CITY OF SYDNEY

Local Planning Panel

Address: 290-294 Botany Road, Alexandria

Application: D/2024/709

Height

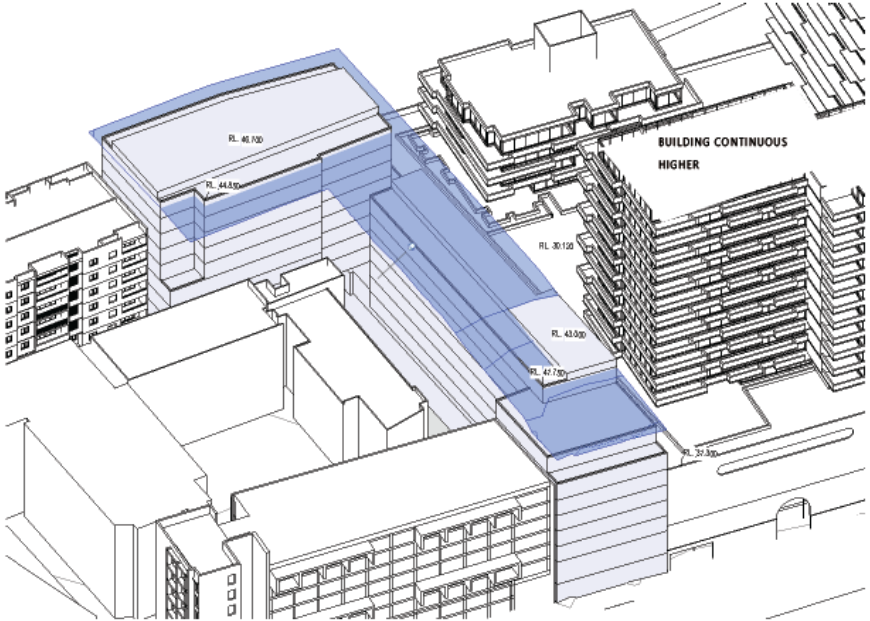
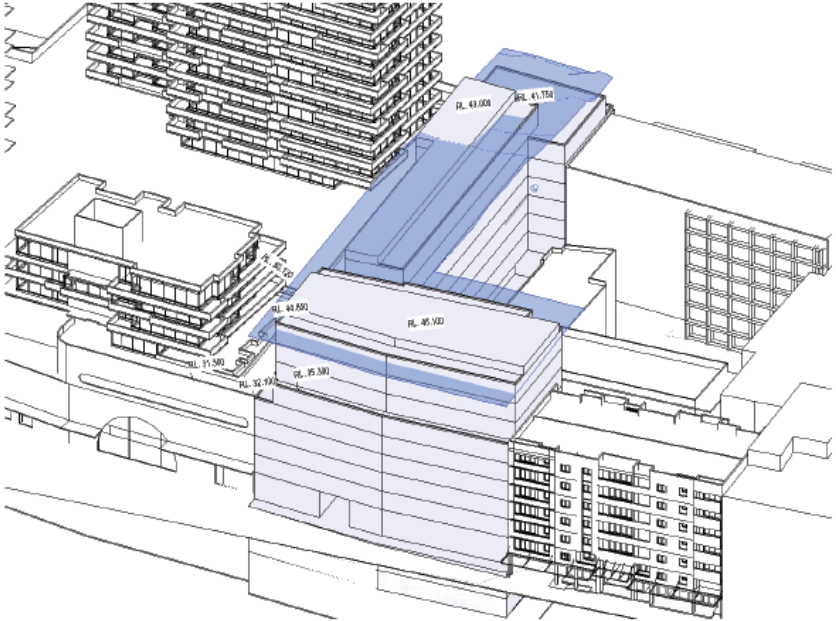
- clause 4.6 variation request
  - ‘service zone’ to allow space for lift overrun and services
  - additional room to provide adequate ceiling height
  - lower in height than approved future adjoining buildings
  - does not have significant adverse (solar, bulk, amenity) impacts
- condition recommended to ensure ‘service zone’ limited to that use only
- request supported

Building separation

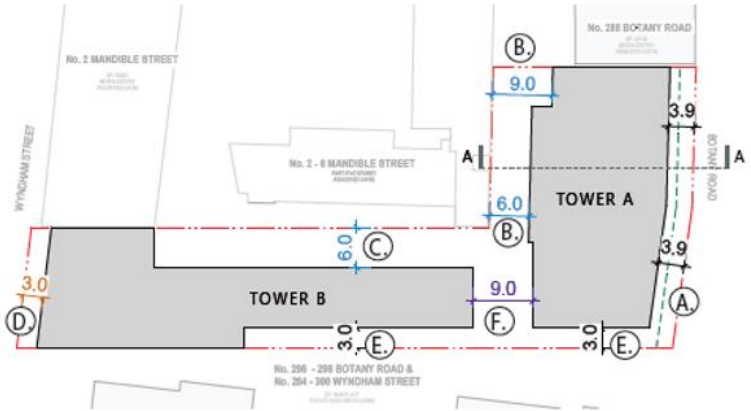
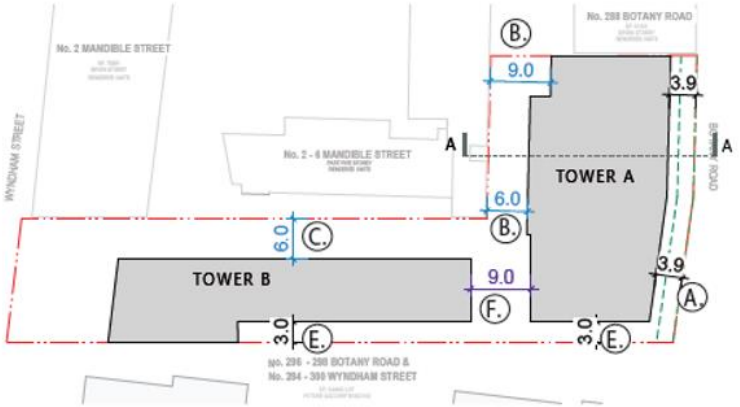
- site is between 0m and 3m from southern boundary
- levels 4 and above align with approved future habitable uses (units)

Building separation

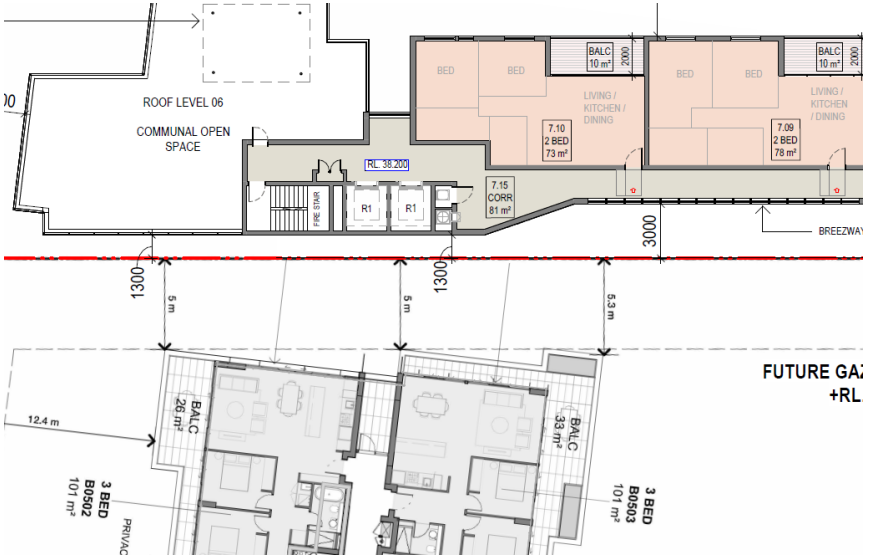
- blank wall provided between subject site and western building on Gazcorp site
- wall setback between 1.3 and 3m from boundary
- condition recommended requiring that blank walls to boundary be architecturally treated

Building separation

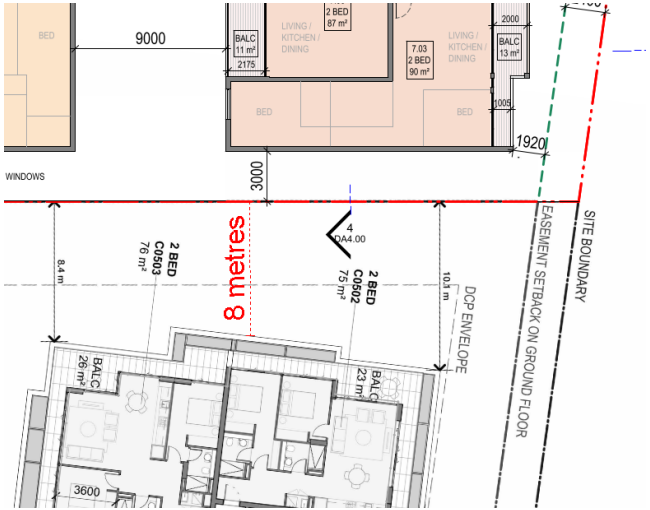
- a 3m setback is provided between building A and eastern building on Gazcorp site, which is setback 8m from boundary
- a blank wall provided on southern boundary
- a total of 11m provided between the two buildings

Cross ventilation

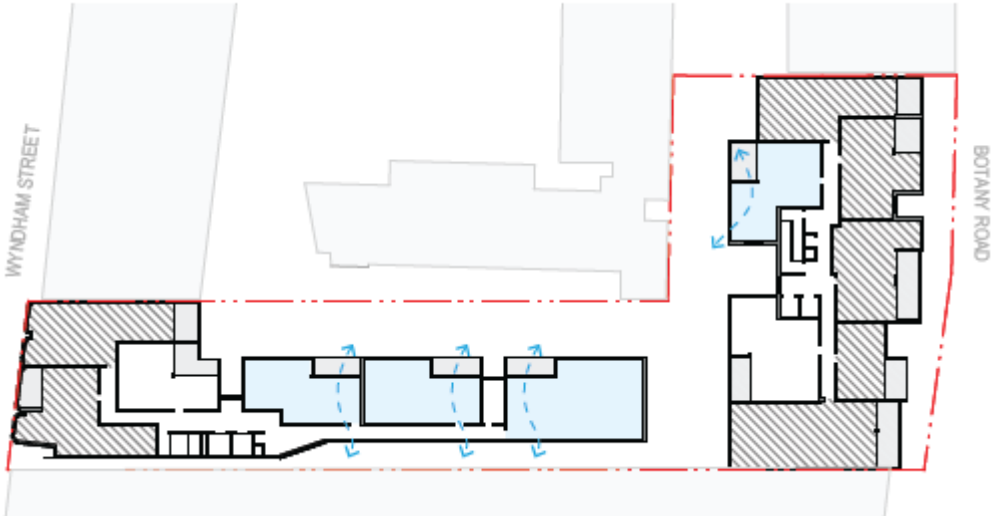
- units facing Botany Road and Wyndham Street noise affected
- site constrained by narrow east-west lot
- design strategies required to provide cross ventilation may include plenum zones, the use of highlight windows to corridor or an additional lift core

Communal open space

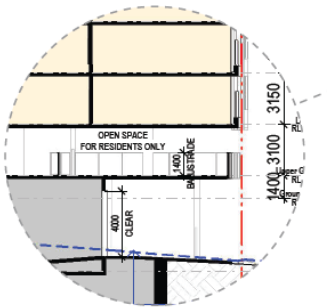
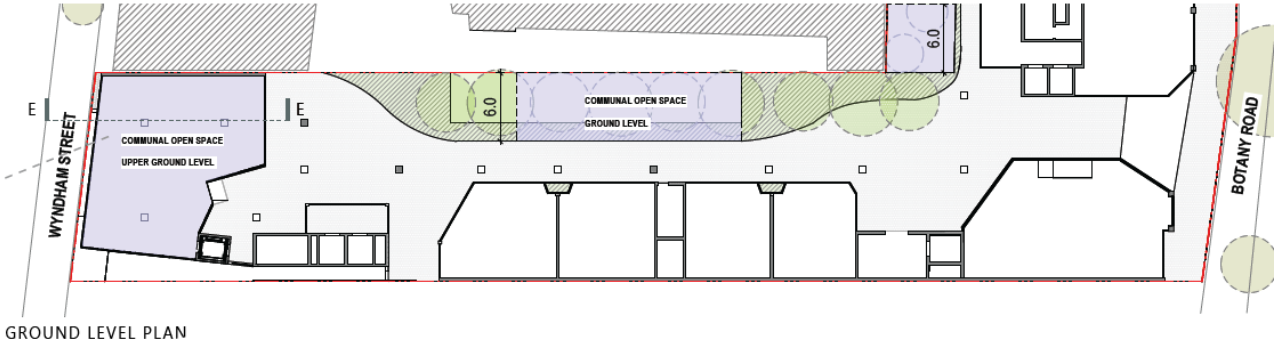
- calculations include areas:
  - partially included in deep soil zone
  - covered for an outdoor gym

- communal space requires further consideration
- condition recommended that this requirement be included in design brief for the competitive design process and as part of any future detailed DA

Through-site link

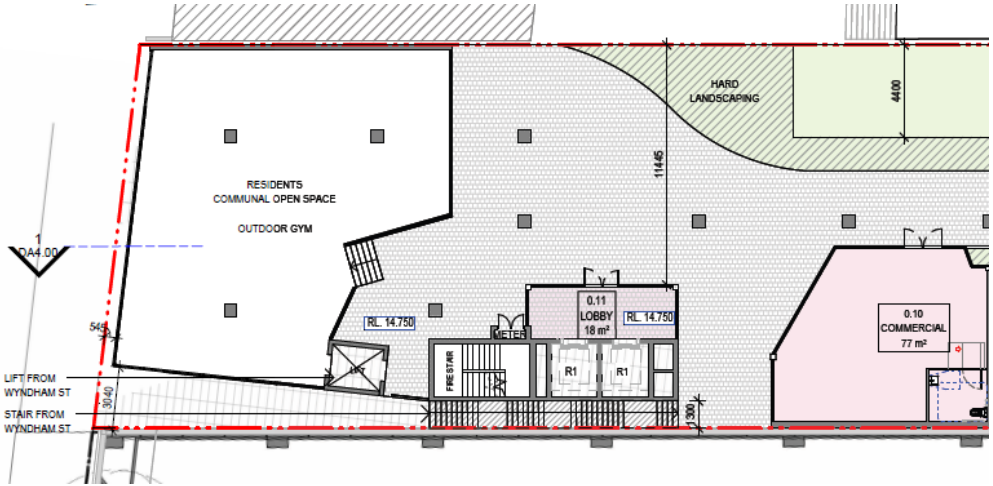
- not required under DCP
- supported to ensure viability of commercial tenancies
- CPTED issues with proposed area
- conditions recommended for these matters to be addressed in detailed DA

Deep soil

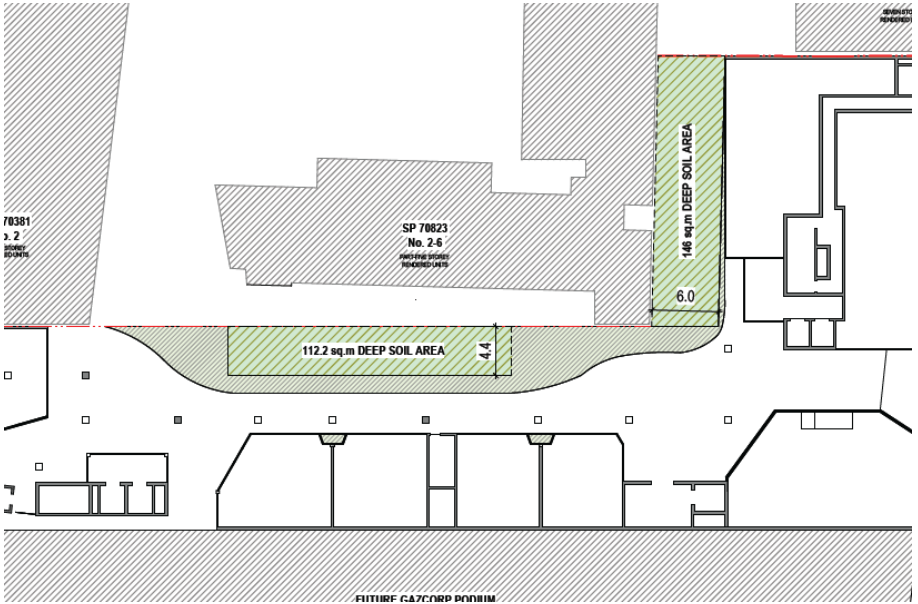
- minimum dimension of 6m required
- proposed areas vary between 4.4m and 6m
- minimum total area of 7% of site required, and proposed development provides 10%
- noncompliance supported
